UNITED STATES PATENT AND TRADEMARK OFFICE

APPLICATION NO.	FILING DATE	FIRST NAMED INVENTOR	ATTORNEY DOCKET NO.	CONFIRMATION NO.
10/573,950	03/29/2007	Thomas Nissl	047956/307840	7925
37305	7590	09/27/2007		
ALSTON & BIRD LLP BANK OF AMERICA PLAZA 101 SOUTH TRYON STREET SUITE 4000 CHARLOTTE, NC 28280-4000			EXAMINER MILLER, CHERYL L	
			ART UNIT	PAPER NUMBER
			3738	
			MAIL DATE	DELIVERY MODE
			09/27/2007	PAPER

Office Action Summary

DETAILED ACTION

Attachment #1 (markedup)

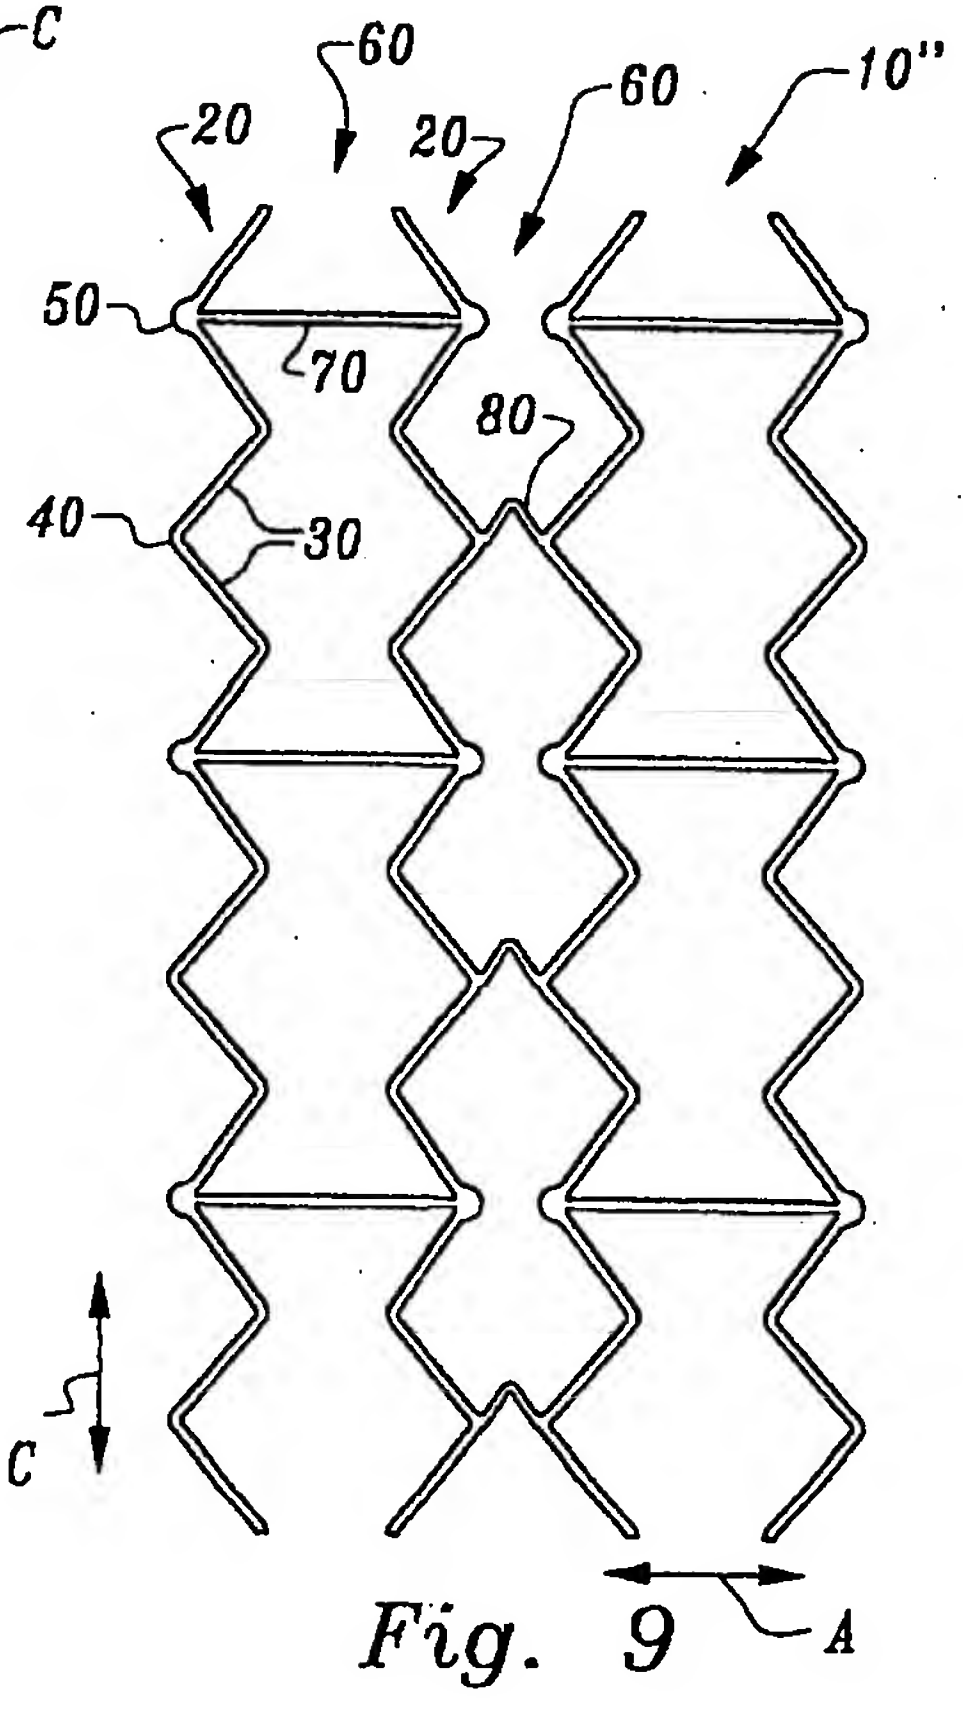
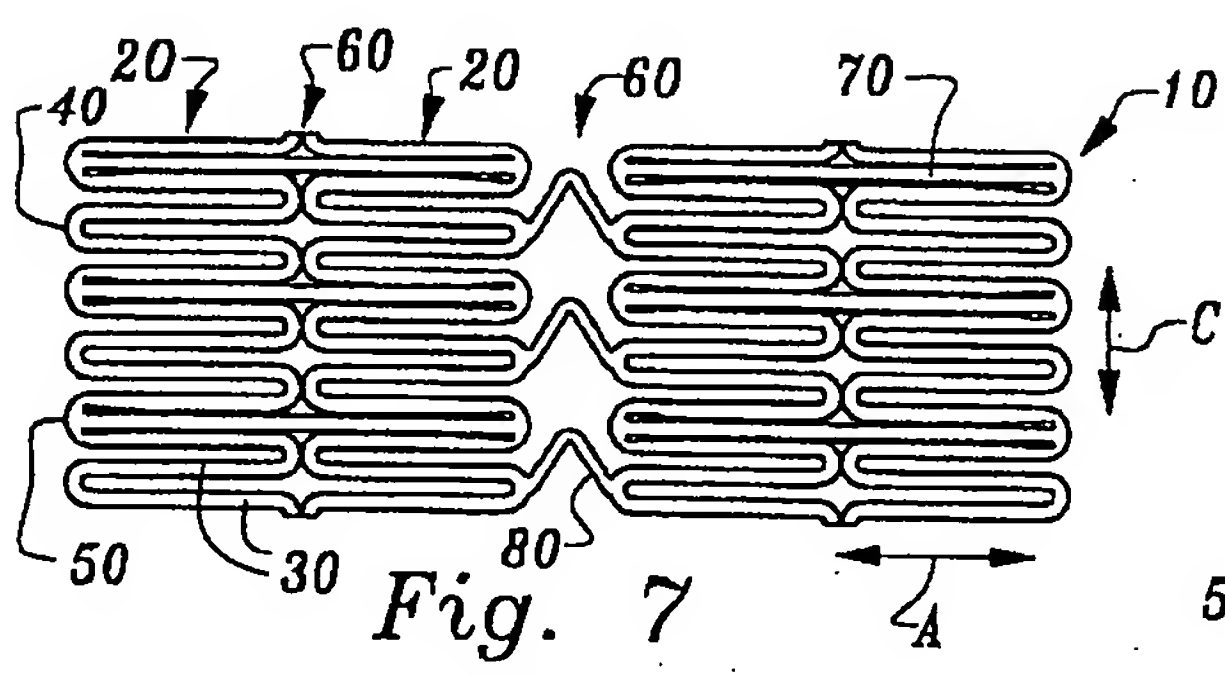
Claims 1-4 and 7 are rejected under 35 U.S.C. 102(b) as being anticipated by Gianturco (US 5,507,771). Gianturco discloses a stent (seen in fig.5 or 6) with at least two annular segments (11, 12) formed by struts (14) and transitional sections (15, 17), the annular segments (11, 12) connected by connectors (considered either 20 or 53), wherein each second transition section (17) has a widened head (18) that is convex and a concave throat between the head and strut (seen in fig.1A). Gianturco discloses the head to be mushroom shaped with rounded edges (see fig.1A). Gianturco discloses the head to be over an adjacent strut (is spaced further

longitudinally than a strut, so is "over" the strut heightwise). Gianturco discloses deflection elements (may be considered other eyelets 15 or any strut 14 in general, since both of capable of accommodating a thread).

*throat region shown concave when expanded is support state.
